**CITY OF ISSAQUAH  
DEVELOPMENT SERVICES DEPARTMENT  
URBAN VILLAGE DEVELOPMENT COMMISSION  
STAFF REPORT  
June 14, 2016**

**File No.:** SDP16-00001  
**Project:** Issaquah Highlands  
Westridge Townhomes I - Site Development Permit

### **Discovery Drive NE**

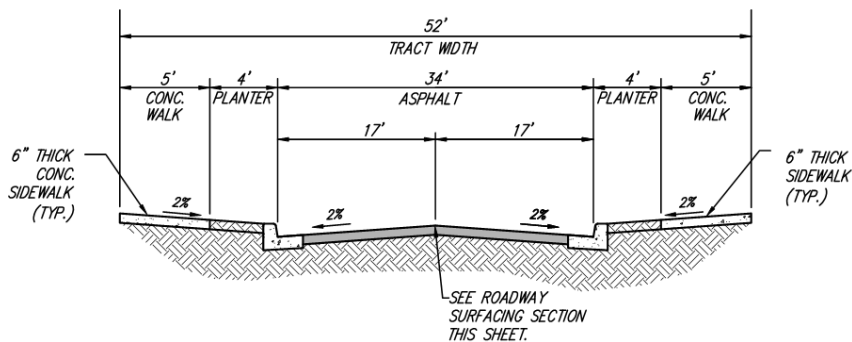
The application includes a connection through Lot B to Discovery Drive at the intersection of 7th Ave NE. This connection is off-site and the applicant must obtain the right to use this area prior to Utility Permit approval [**Condition 29**].

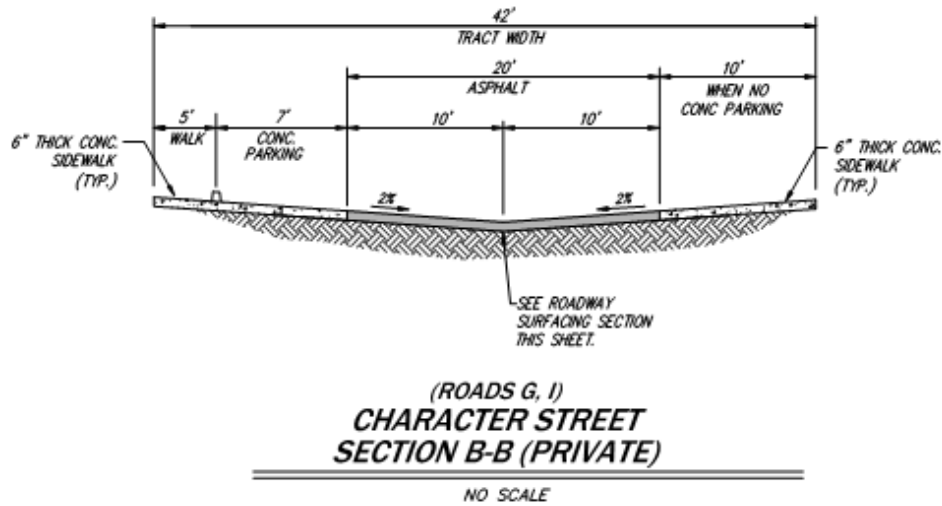
Roads G and I are proposed as Character Streets. A Character Street is a special use street, adopted in the Lakeside Development Agreement, and approved for use in Issaquah Highlands. They are synergistically designed with the architecture and street wall to form an integrated, intimate space that includes the adjacent buildings, the vehicle driving areas and the pedestrian walking areas. They feature a continuous surface throughout the paved portion of the corridor section, thus pedestrians and vehicle zones are defined by vertical elements such as bollards or raised planters and changes in paving materials, color, and/or texture, rather than use of vertical curbs. To create the character and convey the pedestrian priority of the space,

Character Streets are constructed in concrete or other non-asphalt paving. The Character Streets will be evaluated at during the Utility Permit review to determine whether a street cut or a driveway cut should be used.

- 31 The Character Streets (Roads G and I) shall be designed using vertical elements (e.g., planter, bollards, street lights, etc., but not curbs as shown) and changes in the paving material (color and/or texture) to define the pedestrian and vehicle zones. Concrete or other non-asphalt paving materials must be used. The Character Streets will be evaluated at the time of Utility Permit review to determine if street cuts or driveway cuts shall be used.

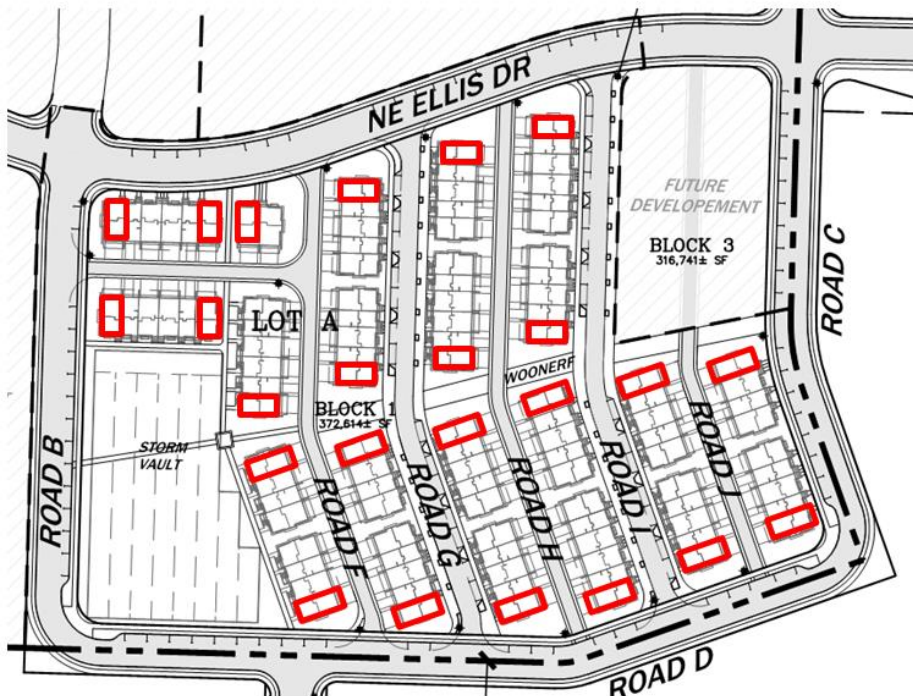
The SDP has many leftover corner areas which are important opportunities to create unique homes that finish the block, provide attractive view termini, and which could appropriately extend the homes toward the street.

The block ends need to be generous to accommodate porches and other elements that turn the corner of the building and finish its exposed side. However, in each case, the buildings adjacent to the above mentioned block end landscape are the same size or no more articulated than buildings without adjacent pedestrians. This is inconsistent with many goals and guidelines: Appendix A: *Creating residential streetscapes that emphasize front porches, .... Encourage dramatic variety of form, mass, plan and fenestration ... and a sense of shared responsibility toward the street, neighborhood, community and environment. Grand Ridge neighborhood streets should provide safe and attractive designs where the whole composition of streets, trees, parkways, walks, front yards and front porches define and contain a common space for residents to stroll, meet, play, and socialize. (underlining added)*

The buildings adjacent to these small, non-functional, leftover landscape areas should be use these areas to accommodate building elements addressing the corner of the block through porches, sun porches, added rooms, etc.... **[Condition 41]**

*Example of location where hardscape elements or robust landscaping is necessary to obscure driveways from adjacent sidewalks*

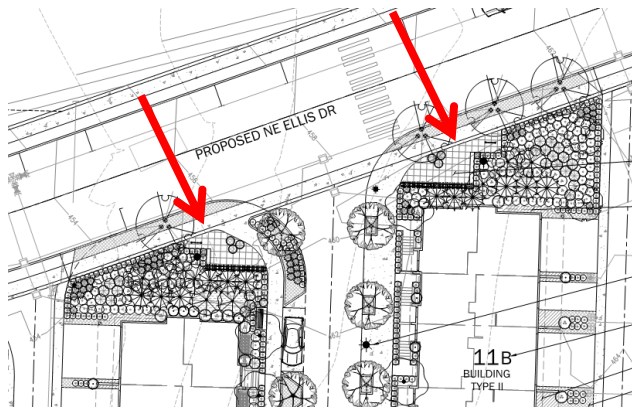
Virtually all of the driveways of buildings located on the perimeter of the project have driveways which will be visible from the adjacent sidewalks unless they are otherwise obscured. Appendix S states that, "To maintain a sense of privacy yet allow for interaction between neighbors, yards and entry courtyards when abutting a street, trail or common space should be separated through physical elements such as open style or low fencing, screens, and low hedges or walls". This indicates the need to provide a landscape or other buffer in order to reduce the presence of the driveways to pedestrians using the adjacent sidewalks. There are several locations where residential driveways are in very close proximity to the sidewalk (see example below). **[Condition 49]**

- 49 Where residential driveways are in direct view of an adjacent sidewalk, their presence shall be minimized providing a landscaped hedge or wall. If plantings are used to meet this condition, they must be planted so that they achieve the desired obscurity of the driveway at the time of planting. This will be verified during the Landscape Permit review and through a visual inspection by the Development Services Department to ensure that plantings are of a mature size at the time of planting.
